Good Homes Alliance

Response to SAP Consultation 2017

Proposed Amendment I Updating Carbon Emission Factors

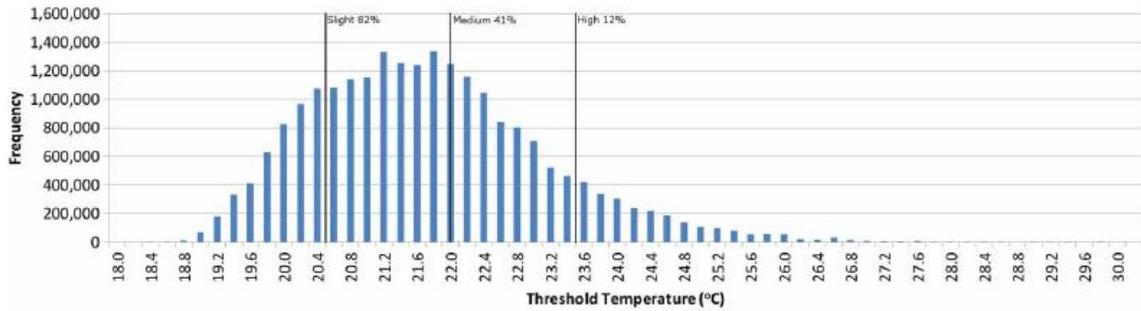
21. For example, Tillson et al (2013)² at UCL used English Housing Survey data to create a SAP Appendix P profile for the stock. They then used this information to show the effect on the risk rating of raising external temperatures by 1.4°C, to simulate climate change. However, for this purpose, the “control” or currently profile might be useful. It shows 12% of housing in the high risk category (SAP 2009). With the new proposals, we might expect the curve to move to the right, just not too far to the right!

The figure shows English housing stock vulnerability to overheating in the current climate. Threshold temperatures predicted by the Standard Assessment Procedure (SAP) indicate the likelihood of the housing stock to overheat in the current climate. The vertical lines show the threshold temperatures that indicate a slight, medium and high risk of overheating, according to SAP 2009, and the cumulative percentages are also shown.

Answer: In light of this, we support the proposals to tighten up data entry provided it is possible to show that the risk profile for the housing stock as a whole does not inappropriately swing too far towards the high risk end of the spectrum so that it is virtually impossible to get a low risk rating.
